UNITED STATES
NUCLEAR REGULATORY COMMISSION
WASHINGTON, D. C. 20555

MEMORANDUM FOR: Walter R. Butler, Director
BWR Project Directorate No. 4
Division of BWR Licensing

SUBJECT: RIVER BEND SITE VISIT AND FOLLOW-UP

Evaluation of River Bend Startup Experience

Figure 1A

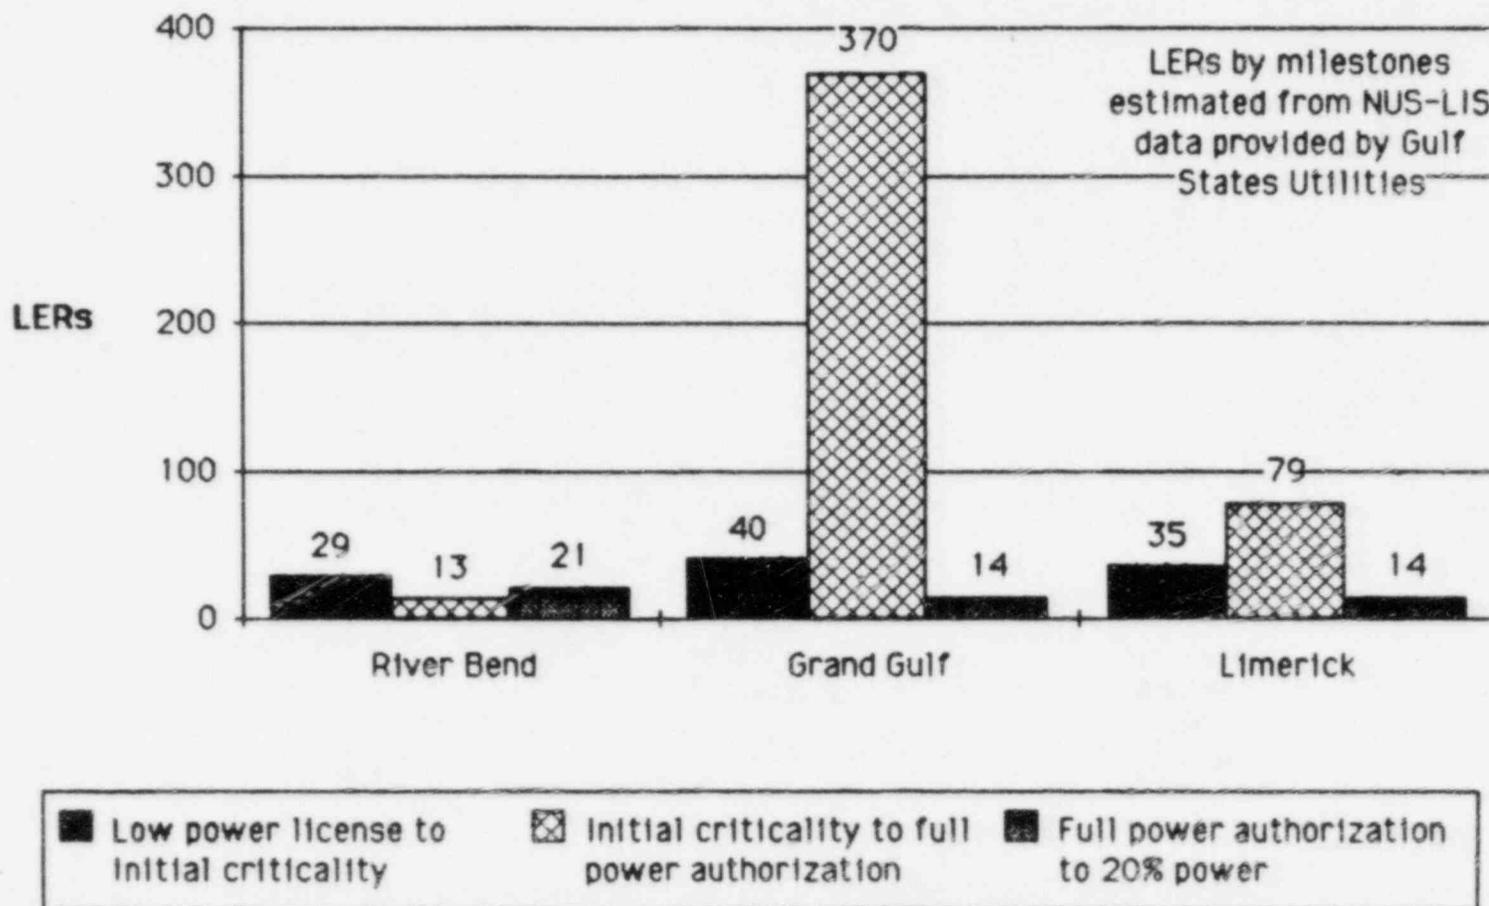
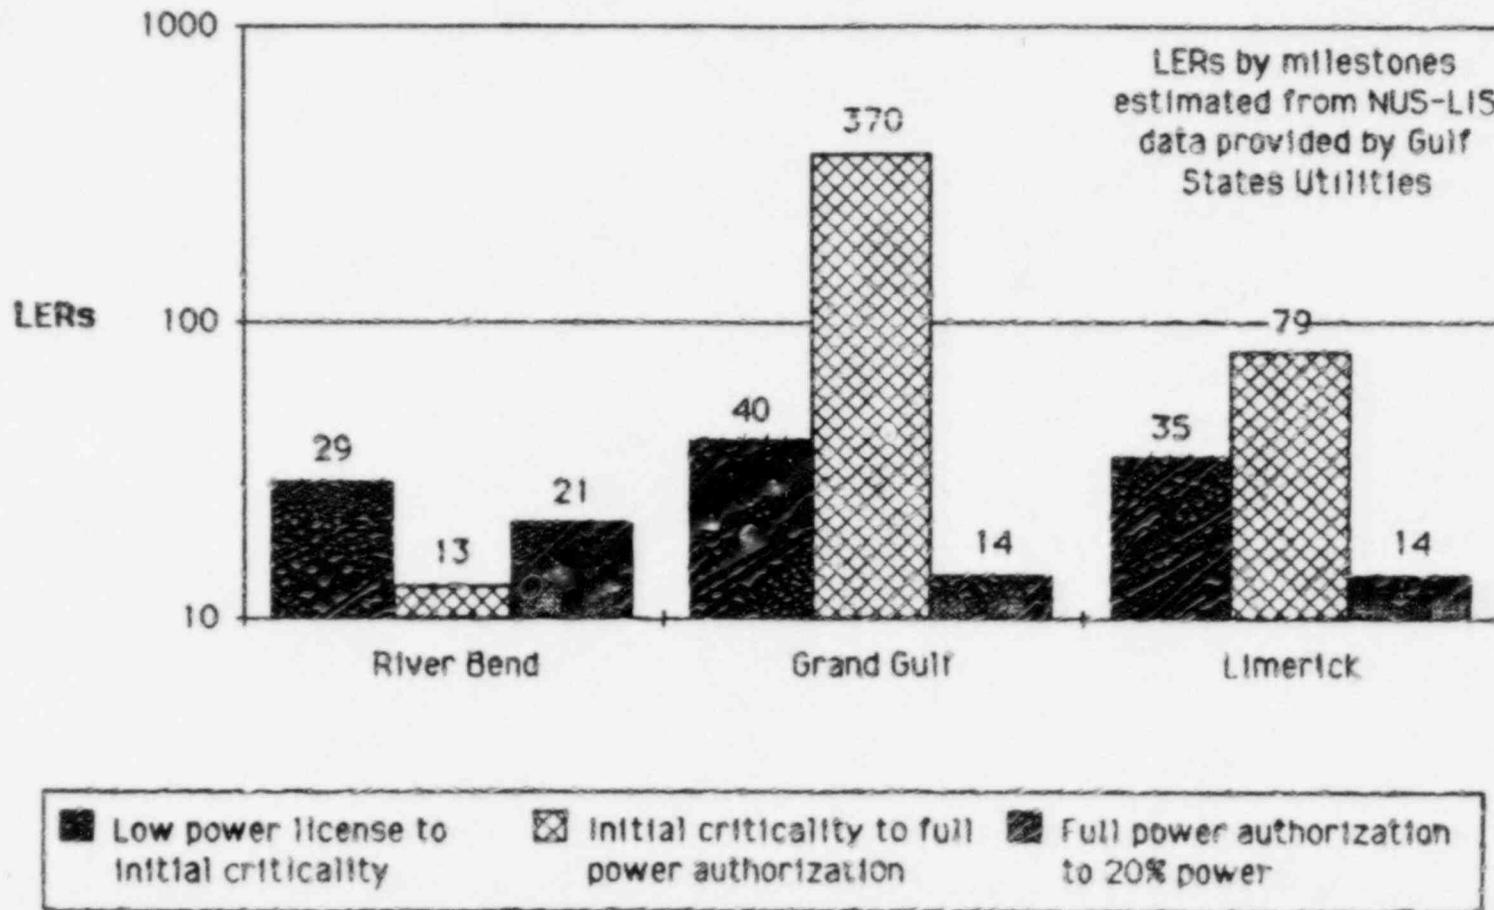
- River Bend experienced a similar number of events during the low power authorization-to-initial criticality phase of their startup program as Limerick and Grand Gulf. The duration of this phase of the startup program at the three plants was similar--about two months.

- River Bend experienced a significantly smaller number of events during the initial criticality-to-full power authorization phase of startup than Limerick and Grand Gulf. However, the duration of this phase of startup at River Bend was less than a month, contrasted to about seven and one-half months at Limerick and twenty-five months at Grand Gulf.

- River Bend is experiencing a somewhat greater number of events since full power authorization than the comparable phase of startup at Limerick and Grand Gulf. The duration of this phase from full power authorization-to-20% rated power was similar at all three plants--about one month.

Figure III

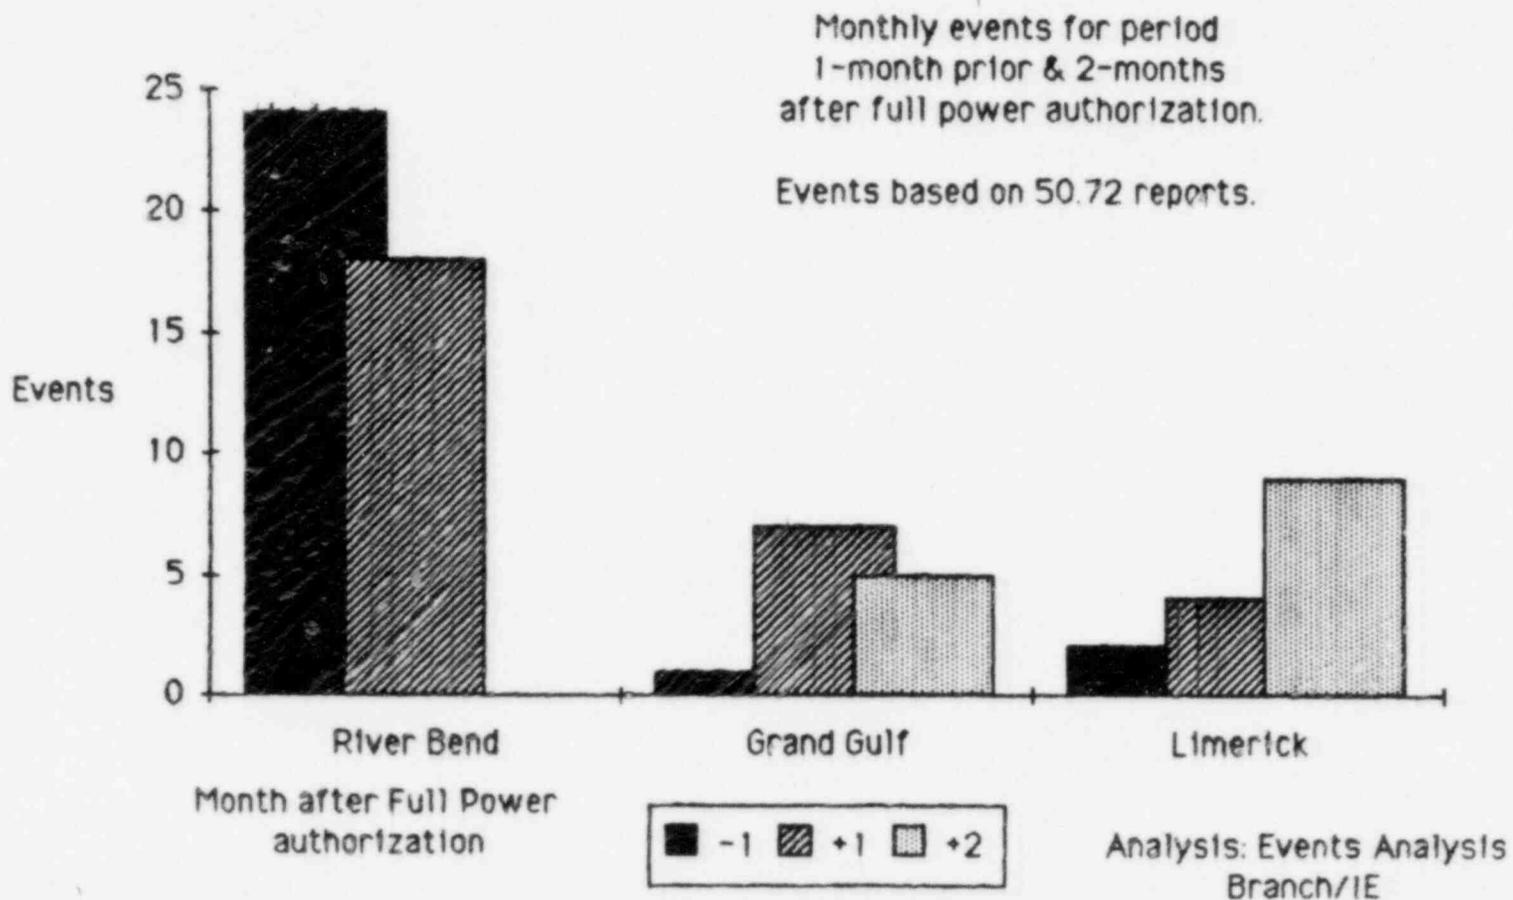
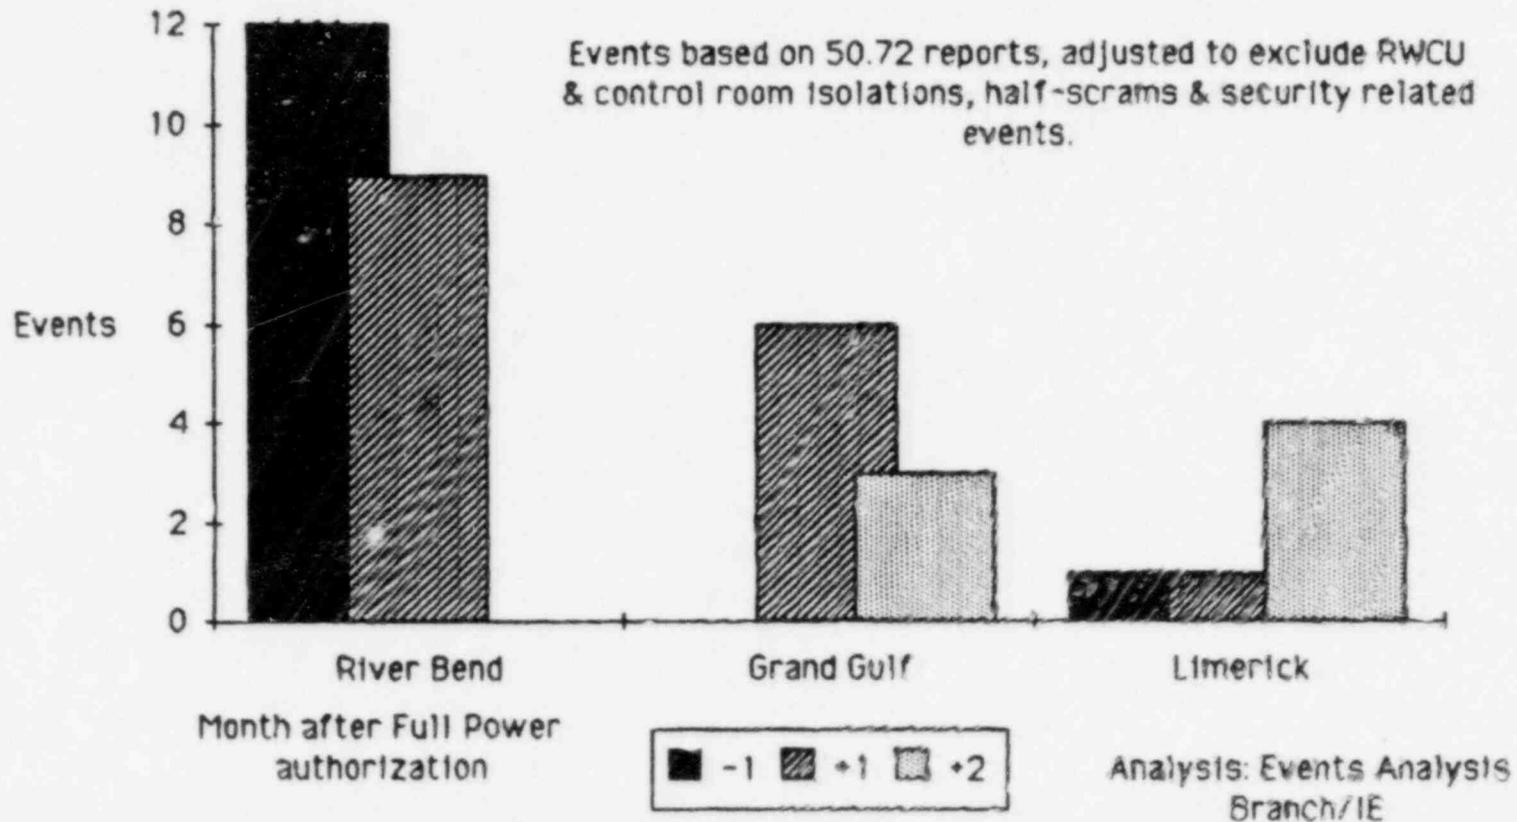
- Evaluated on a month-by-month basis, River Bend is experiencing a larger number of events during the time period near full power authorization (Figures II & III). The number of scrams is similar to those of Grand Gulf, but greater than Limerick's during this period (Figure IV).
